ADDENDUM NO. 1

RE: South Conway Lift Station Sanitary Sewer & Waterline Improvements
RFB # 20-179-03-12

You are hereby notified of the following changes to the plans, proposal, and/or specifications for the above-mentioned project.

PROPOSED SERVICE POLE, SWITCH RACK DETAIL
SCALE: NTS

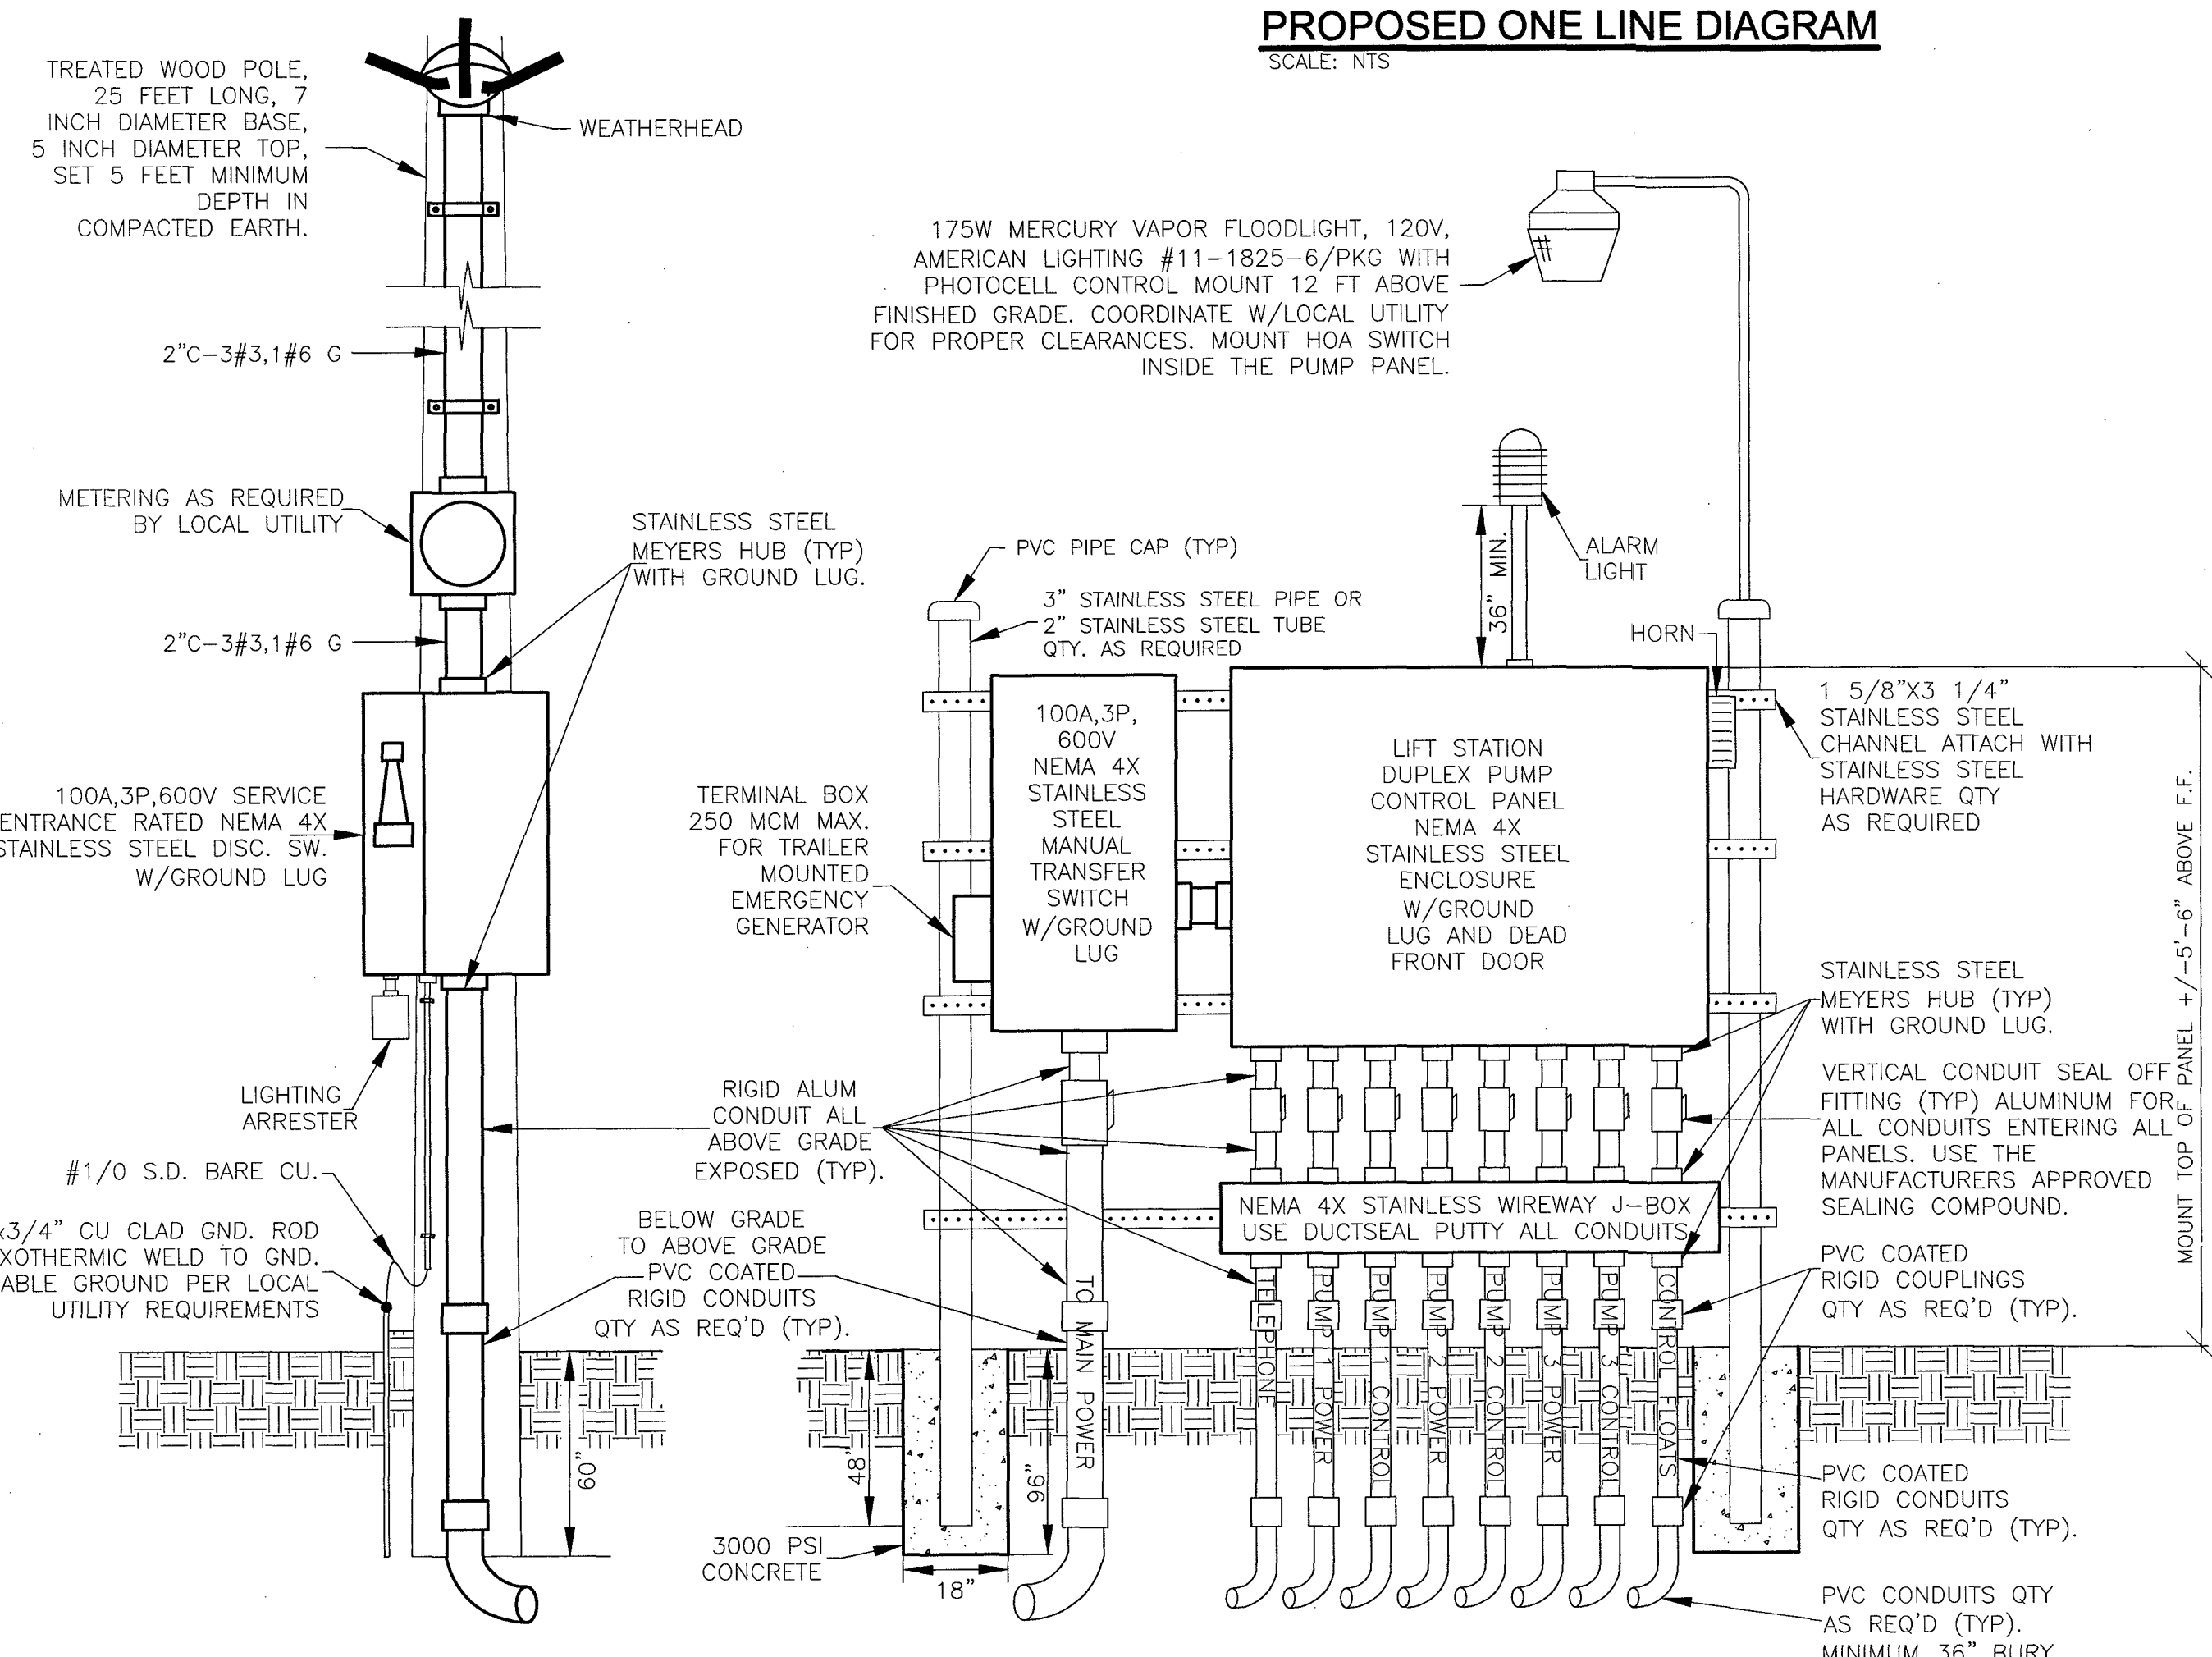
1. Sheet C6 has been revised to show the correct size of casing.
2. Sheet C10 has been revised to reflect proper fitting sizes.
3. Sheet C16 has been revised reflecting 3 submersible pumps.
